CONTRACT CHANGE ORDER NO. _____
SHEET ____ OF ____

SAN FRANCISCO OAKLAND BAY BRIDGE
EAST SPAN SEISMIC SAFETY PROJECT

SKYWAY CLEANUP ITEMS
TRAVELER DECKING REPLACEMENT

MARK	DATE	DESCRIPTIONS	BY	CH'D	CCO#
0	03/28/11	SKYWAY BIKEPATH TRAVELER COMPLETION WORK	TH	JD	178

SECTION A-A
NEW BIKEPATH TRAVELER BELVEDERE BALCONY DECKING
1:5

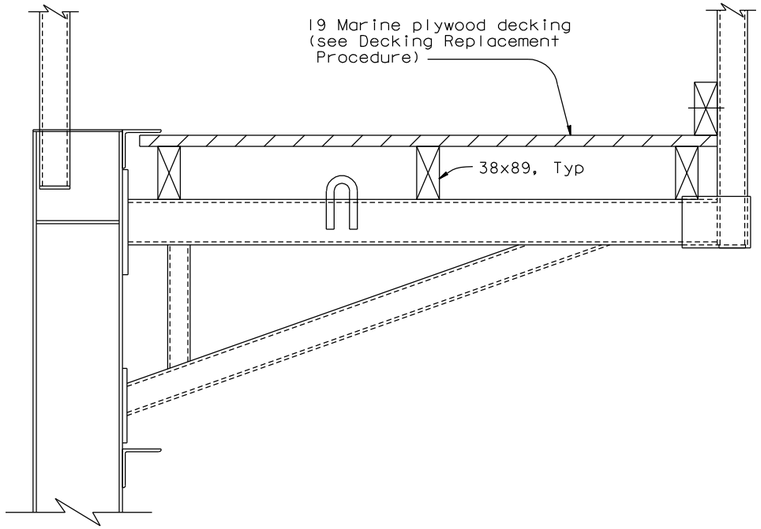
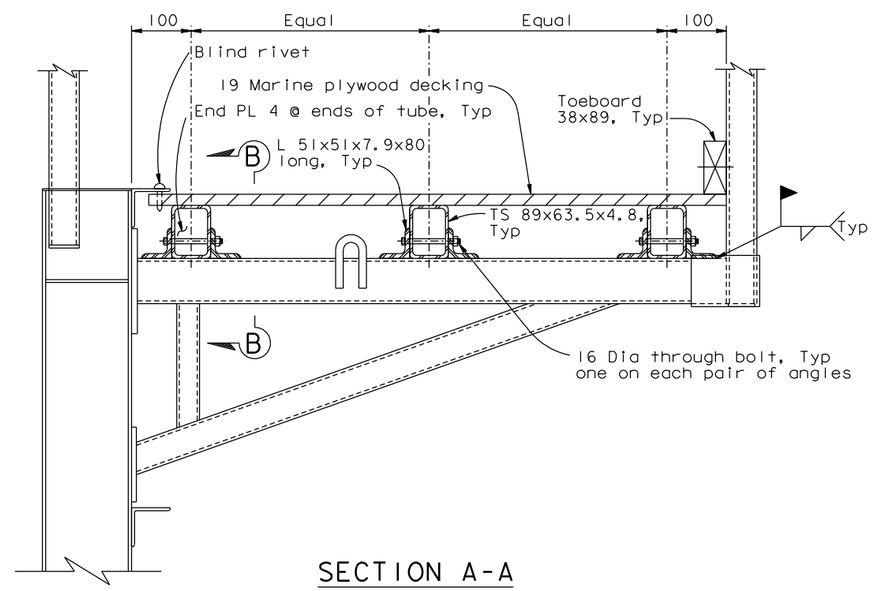
DECKING REPLACEMENT PROCEDURE:

1. Remove Marine plywood and 38x89 lumber.
2. Install structural angles and tubing. Tube sections to be ASTM A500 Grade C or ASTM A300 Grade B with mill certificates satisfying Grade C Fy & Fu, subject to review and approval of the Engineer. Angles to be ASTM A572 Grade 42 or ASTM A709 Grade 345.

3. Bolts
   a) All bolts to be ASTM grade A325, unless noted otherwise
   b) Fabricator is to supply a nut and one hardened washer with each bolt unless noted otherwise.

c) All bolts, nuts, and washers are to be galvanized.
   d) All 16 Dia bolts shall be imperial (5/8 inch) size.
4. Install new plywood decking and toeboard. Plywood decking shall conform to or exceed the requirements of U.S. Product Standard PS-1-9S for APA Structural 1 AB Marine Grade. Plywood shall be pressure treated. Plywood decking shall be painted on all sides. Wooden toeboards shall be pressure treated S4S Douglas Fir. Toeboards shall be painted on all sides.

5. Plywood decking shall be attached using blind rivets. Blind rivets shall be stainless steel, 4.8 mm diameter and shall be installed at 305 mm maximum on center.

6. Areas with damaged paint or with no paint shall be cleaned and painted. Any damage to the galvanized surfaces shall be repaired with zinc rich primer. Galvanized surfaces shall be finish painted.
